**PLANNED UNIT DEVELOPMENT  
& SUBDIVISION STAFF REPORT****Date: April 3, 2014****DEVELOPMENT NAME**

First Baptist Church of Tillman's Corner Subdivision

Planned Unit Development to allow multiple buildings on a single building site and Subdivision approval to combine multiple lots to create one legal lot of record.

# SITE PLAN

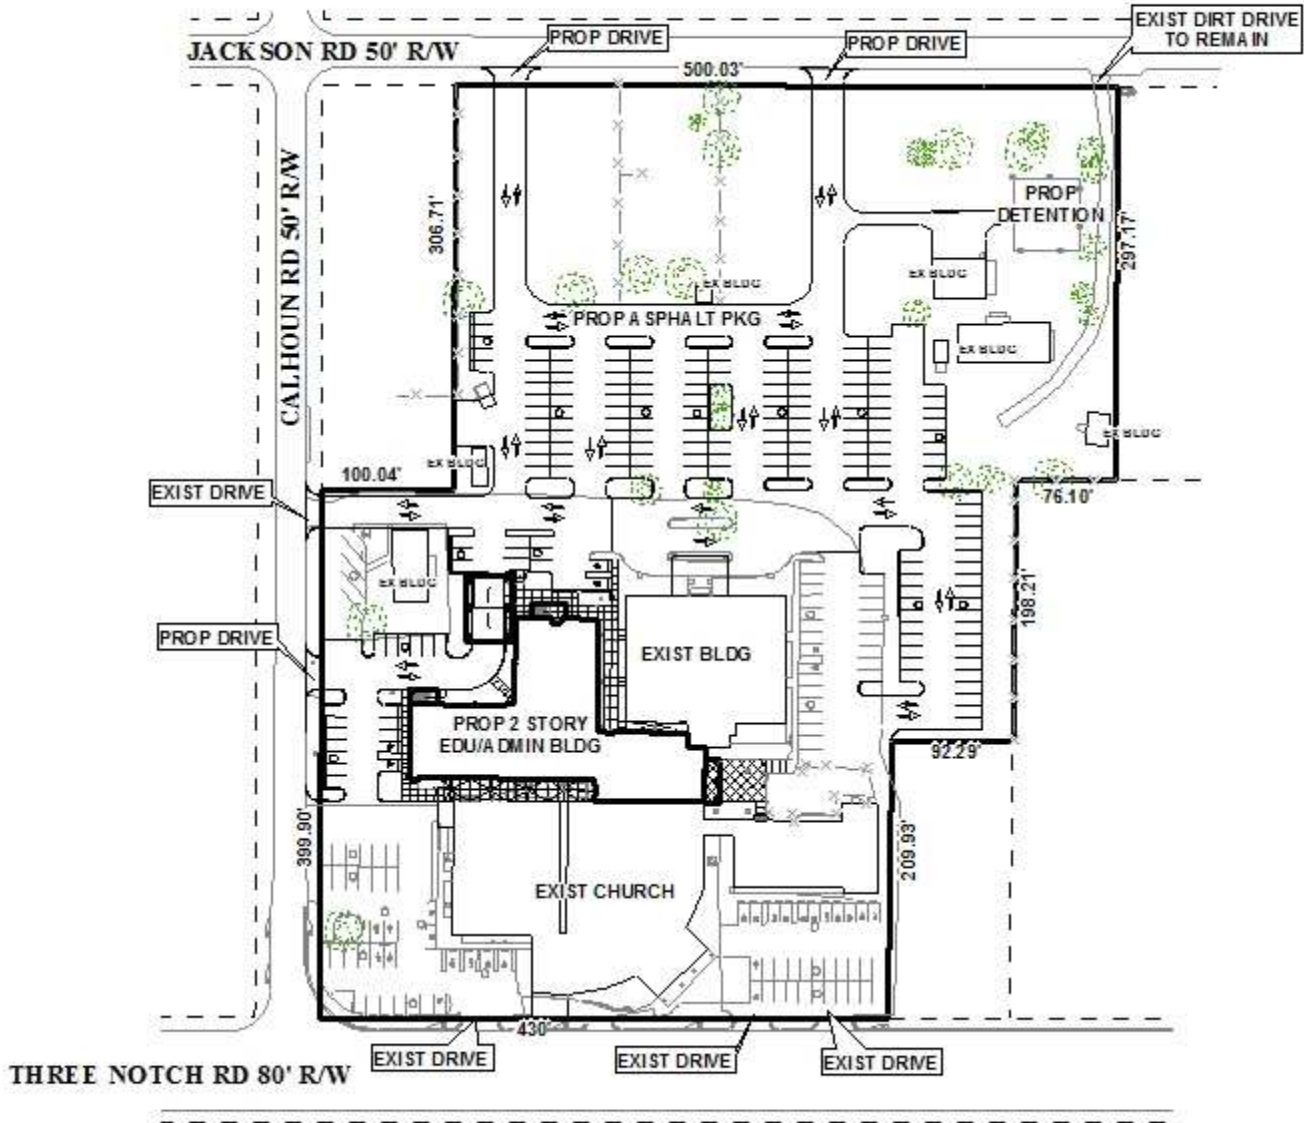
Driveway number, size, location and design to be approved by Traffic Engineering and conform to AASHTO standards. The southern most driveway on

Calhoun Road must be reduced in width, by maintaining the proposed northern radii and moving the southern radii to match the adjacent aisle width. All new on-site parking, including ADA handicap spaces, shall meet the minimum standards as defined in Section 64-6 of the City's Zoning Ordinance.

Access management is a concern due to the site's fronting 3 streets with multiple curb-cuts and existing substandard vehicle maneuverability areas. The site has 13 existing curb-cuts and as the applicant proposes to improve access, 10 curb-cuts will still remain. The southern lot line, which runs along Three Notch Road, has 4 curb-cuts and the western lot line along Calhoun Road has 3 curb-cuts, one of which appears to be over 75'  $\pm$  wide. The curb-cuts access existing and proposed parking area. It should be pointed out that some of the existing travel aisles measure only 9'  $\pm$  and, as such, Staff recommends a one-way traffic circulation if the existing parking areas are remain non-compliant. Jackson Road has 6 existing, substandard curb-cuts. The applicant proposes to eliminate 3 and retain and improve 2 of the curb-cuts. As one of the gravel drives appears to remain unimproved, the site plan should be revised to illustrate a paved drive.

The site plan illustrates several existing issues within the site. A portion of the eastern property line north of Three Notch Road appears to share access with the adjacent lot to the east, which is

not included in this request. The site plan should be revised to illustrate curbing and landscaping along the eastern property line to prevent vehicular access between the two lots. If the applicant desires to continue a shared access, the lot to the east should be included in the PUD request.

All proposed parking areas appear to be compliant in terms of travel aisle width and parking stall dimensions; however, the site plan does not depict any proposed lighting. Any new lighting on the site will have to comply with the requirements of Sections 64-4.A.2., 64-6.A.3.c., and 64-6.A.8. of the Zoning Ordinance. A note reflecting this requirement should appear on the site plan, and photometric plans will be required at the time of permitting.

It should be pointed out that the site plan does not depict any sidewalks along any street frontages. The site plan should be revised to illustrate sidewalks along all street frontages or the applicant should submit a Sidewalk Waiver request.

Also, the site plan does not depict a residential buffer nor frontage trees and landscaping. A 10' residential buffer should be required along the northwestern lot line where the property abuts an adjacent residentially developed lot and along the northeastern lot line where the property abuts a vacant lot which may be developed residentially. The site plan should be revised to illustrate the buffer in compliance with Section 64-4.D.1. of the Zoning Ordinance and illustrate and quantify full compliance with the tree and landscaping requirements of Section 64-4.E. of the Zoning Ordinance.

The site plan depicts a dumpster and it should be noted that all dumpsters shall be in compliance with Section 64-4.D.9. of the Zoning Ordinance to include being enclosed on at least three sides and connected to sanitary sewer.

- 1) Provision of a written statement that the owner will petition for inclusion or exclusion from the city;
- 2) Revision of the site plan to depict a permanent closure of the vehicular access to the adjacent property to the east with curb and landscaping, or the revision of the PUD request to include the lot to the east and shared access;

- 3) Revision of the site plan to comply with Traffic Engineering Comments: *(Driveway number, size, location and design to be approved by Traffic Engineering and conform to AASHTO standards. The southern most driveway on Calhoun Road must be reduced in width, by maintaining the proposed northern radii and moving the southern radii to match the adjacent aisle width. All new on-site parking, including ADA handicap spaces, shall meet the minimum standards as defined in Section 64-6 of the City's Zoning Ordinance.);*

- 4) Coordination with Staff to improve onsite traffic flow and revision of the site plan to illustrate one-way traffic flow with compliant 12' travel aisles/vehicular maneuverability area where travel aisles are less than 24';

- 5) Revision of the site plan to illustrate proposed lighting along with a note stating any new lighting on the site will have to comply with the requirements of Sections 64-4.A.2., 64-6.A.3.c., and 64-6.A.8. of the Zoning Ordinance;

- 6) Depiction of a paved driveway in the northeast corner of the lot if the applicant desires to retain the curb-cut;
- 7) Depiction of sidewalks on the site plan along all street frontages or the submission of a Sidewalk Waiver request;

- 8) Depiction of a 10' residential buffer on the site plan along the northeastern and northwestern lot lines in compliance with Section 64-4.D.1. of the Zoning Ordinance;

- 9) Revision of the site plan to illustrate and quantify full compliance with the tree and landscaping requirements of Section 64-4.E. of the Zoning Ordinance;

- 10) Revision of the site plan to include a note stating that all common and detention areas shall be maintained by the property owners;
- 11) Revision of the site plan to reflect sufficient dedication to provide 30' as measured from the centerline of both Calhoun and Jackson Roads;

- 12) Revision of the site plan to depict a corner radius in compliance with Section V.D.6. of the Subdivision at the intersection of Calhoun and Three Notch Roads;

- 13) Revision of the 25' minimum building setback line on the site plan to reflect dedication and corner radius;
- 14) Revision of the site plan to depict a 35' minimum building setback line along Three Notch Road; and

- 15) Depiction of a dumpster on the site plan in compliance with Section 64-4.D.9. of the Zoning Ordinance.
